Project Name: Modern Merchandising, Inc.

IMPACT OF PROPOSED LA BELLE'S BUILDING  
ON THE 100-YEAR FLOOD PLAIN OF  
LEACH CREEK, GRAND JUNCTION, COLORADO

Re: Proposed La Belle's Building on 100-year Flood Plain of  
Leach Creek

SUBJECT: Floodplain Permit Application for LaBelles at 24 Road and F Road.

EXHIBIT I

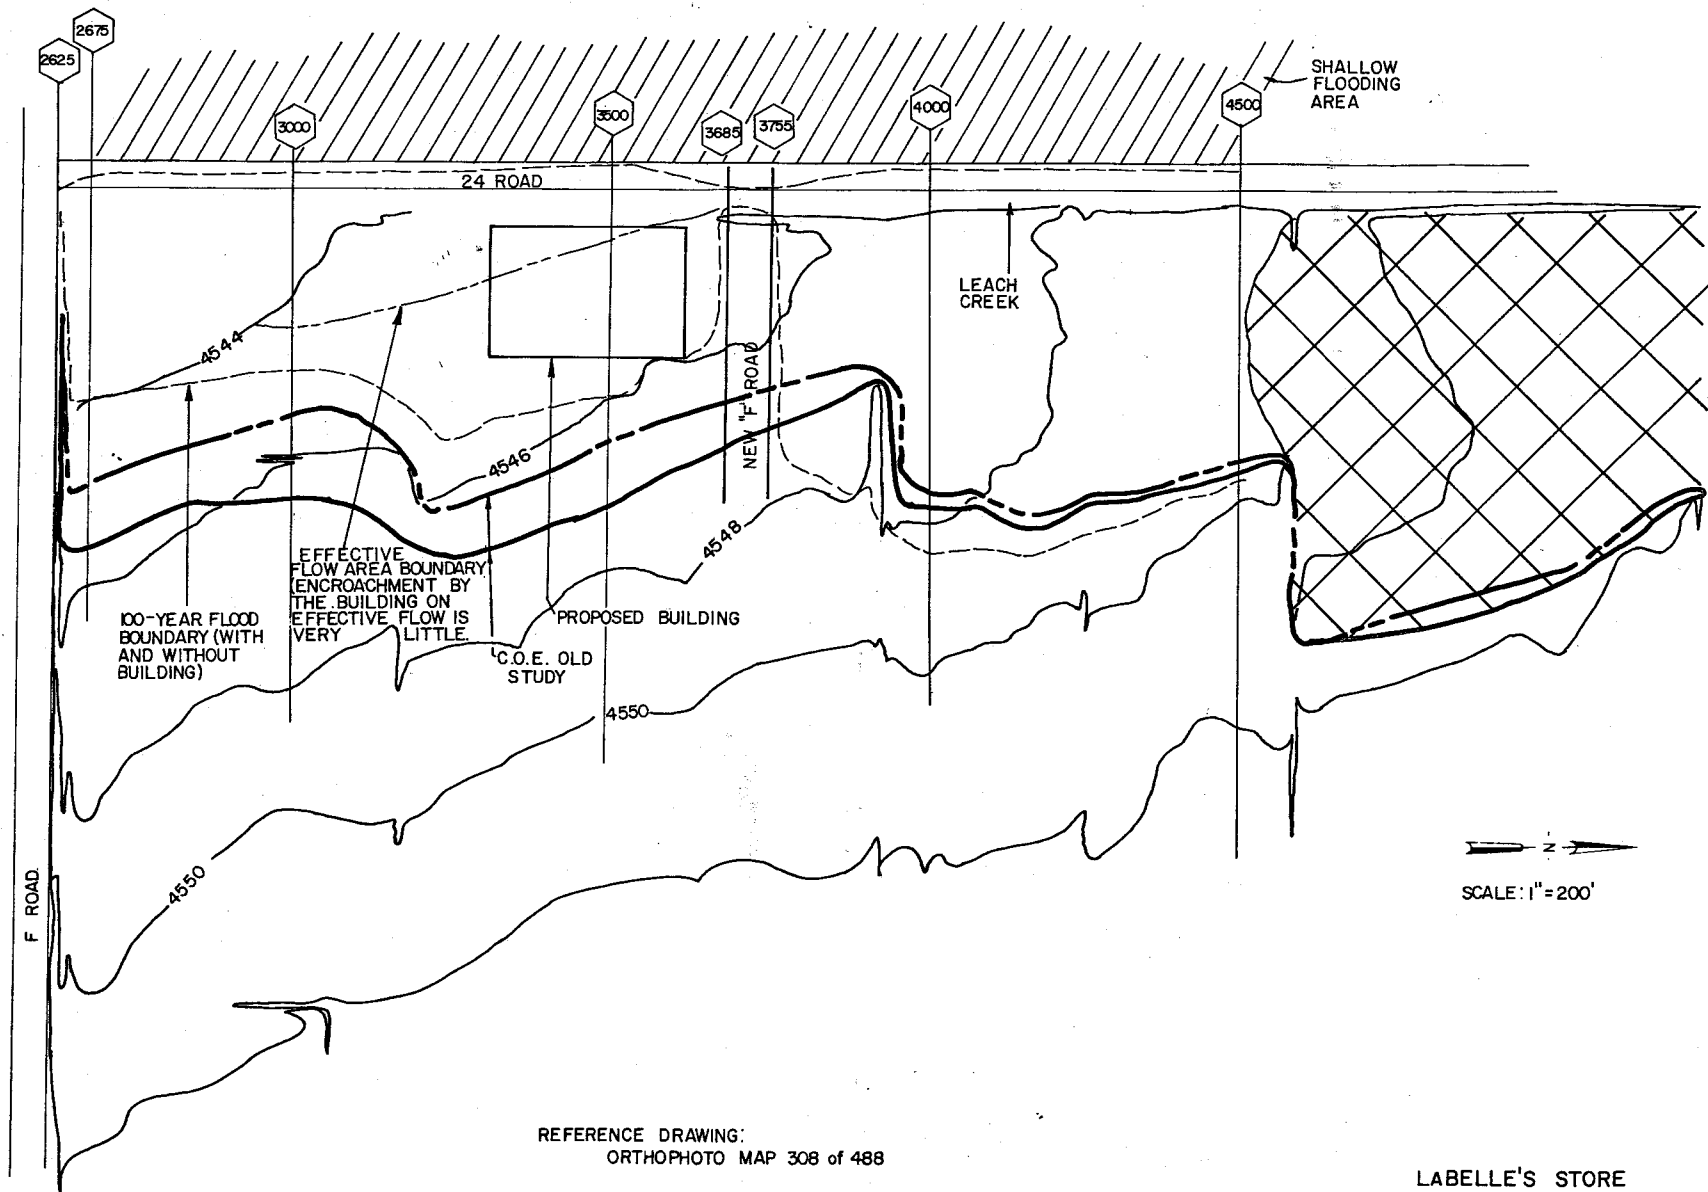
1. Many of the requirements for the application for a "Flood Plain Permit" are not met. (See Section G of Ordinance 1482 and the permit application.)
2. Section F of Ordinance 1482 prohibits the erection of structures or more than "nominal" filling in the floodway district.
3. Your hydraulics analysis should include delineation of the "floodway district" and the floodfringe district" for
  - (a) existing site conditions,
  - (b) improved site conditions including all proposed grading.

The "floodway district" is of course that portion of the designated flood plain which is required to carry and discharge a 100-year flood without cumulatively increasing the water surface elevation more than one foot at any point.

The hydraulics analysis should also include estimated flow velocities as your submitted report does. The grading proposal should include rip-rapping or other appropriate erosion control protection.

FIGURE 1  
LEACH CREEK, GRAND JUNCTION, COLORADO

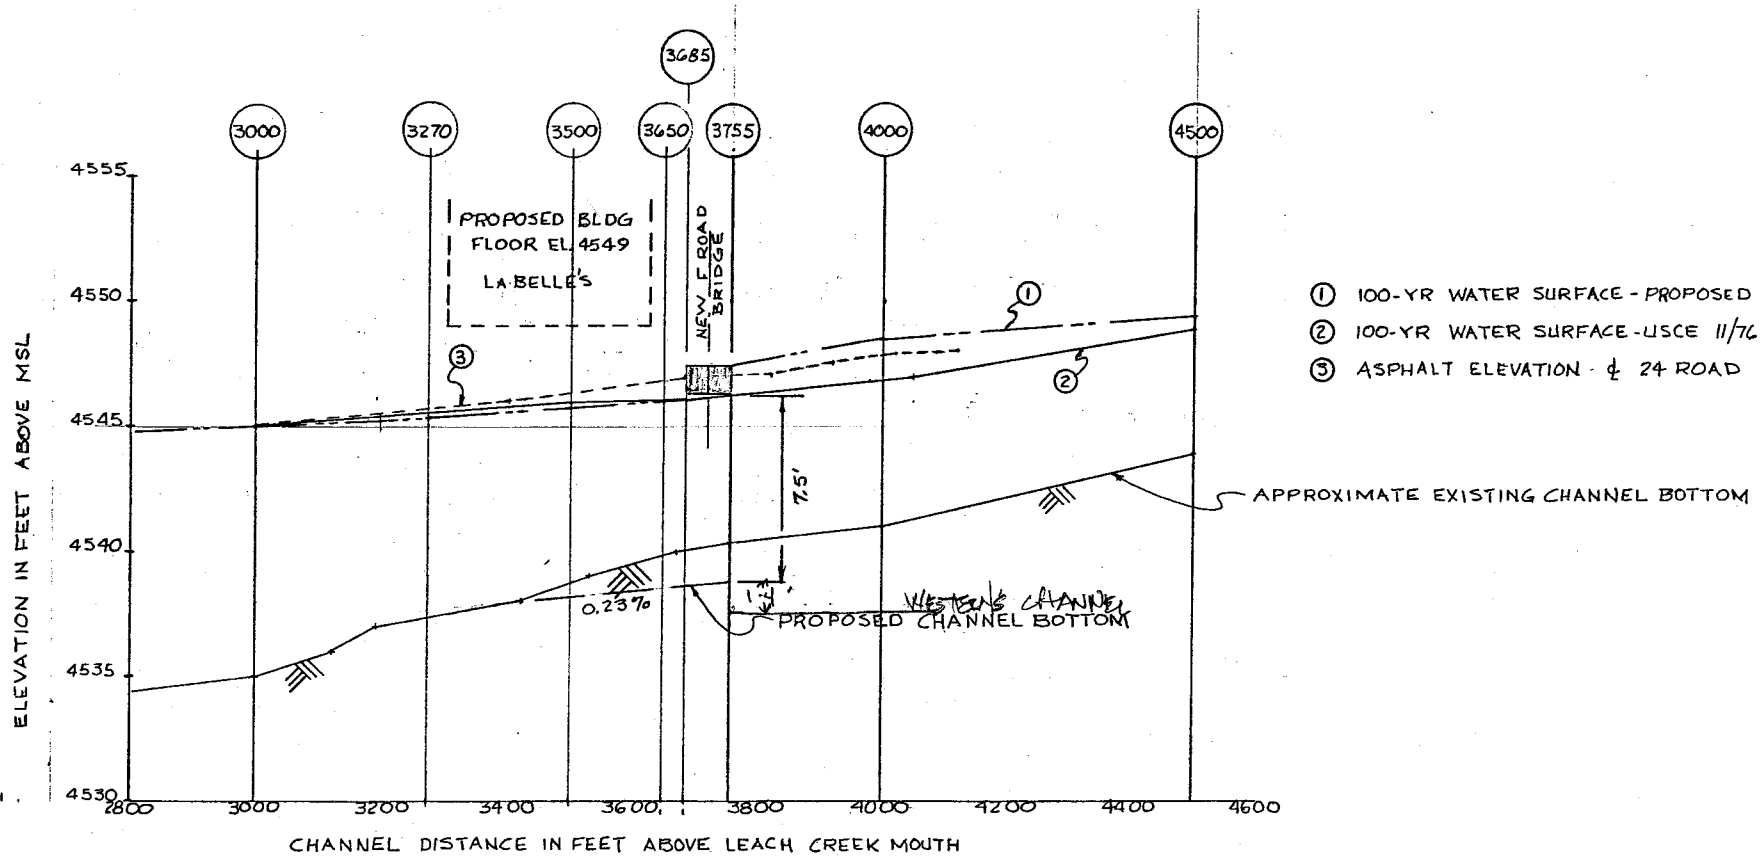
1. The hydraulic concept proposed is reasonable and is acceptable to this office. Elevation of the building, enlargement of Leach Creek, and flood detention in the parking lot are very good flood mitigation proposals.

2. Additional right-of-way and/or easement width should be deeded to accomodate the proposed widened Leach Creek channel to insure no future encroachments into the flood channel.

3. The professional engineer responsible for this report should sign and stamp the report.
4. I called Ed Currier today concerning the references to future modifications to the F Road bridge and the Leach Creek channel upstream to accomodate the 100 year flow of 1800 cfs. He related that a concrete wall of some sort was built between the pipe pilings supporting the bridge, (Their as-builts do not show this) and that as much as "about 10 feet" of depth below the beams would not affect the structural integrity of the bridge.

The proposed channel improvement is designed to carry the USCE calculated 100-year storm flow of 1800 cfs entirely within the channel banks. Figure 1, attached to these comments, shows a profile of Leach Creek and the relative elevations of the 100-year storm flows with and without recent F Road changes and proposed channel alterations.
